Clinton Power Station, Unit 1
Facility Operating License No. NPF-62
NRC Docket No. 50-461

Subject: Additional Information Related to License Amendment Request to Remove Operating Mode Restrictions for Performing Division 3 AC Sources Surveillance Testing (TAC NO. ME4949)

Additional Information Related to License Amendment Request to Remove Operating Mode Restrictions for Performing Division 3 AC Sources Surveillance Testing

Figure 1: SR 3.8.1.8 Markup

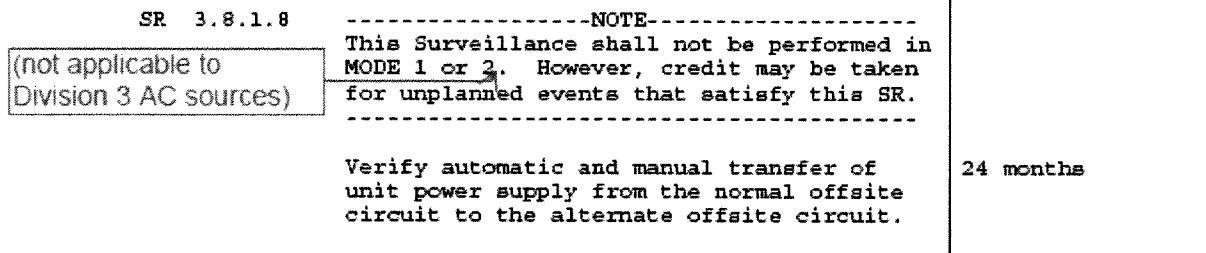
NRC Request No. 1. *In Section 2.1, surveillance requirement (SR) 3.8.1.8, of license amendment request (LAR), the licensee states, "Revise Note 2 to remove restriction that prohibits performance of the SR in Modes 1 or 2 for Division 3 AC Sources only." However, the technical specification (TS) markup sheet for SR 3.8.[1.]8 attached to the LAR does not show Note 2. Please provide clarification to this discrepancy.*

The Section 2.1 verbiage related to Surveillance Requirement (SR) 3.8.1.8 contains a typographical error. As shown in Technical Specifications (TS) markup associated with SR 3.8.1.8 in Figure 1 below, this SR contains only one note.

The Section 2.1 discussion associated with SR 3.8.1.8 should read as follows:

SR 3.8.1.8: Revise the Note to remove the restriction that prohibits performance of the SR in Modes 1 or 2, for Division 3 AC sources only. This SR requires verification of the automatic and manual transfer of unit power supply from the normal offsite circuit to the alternate offsite circuit.
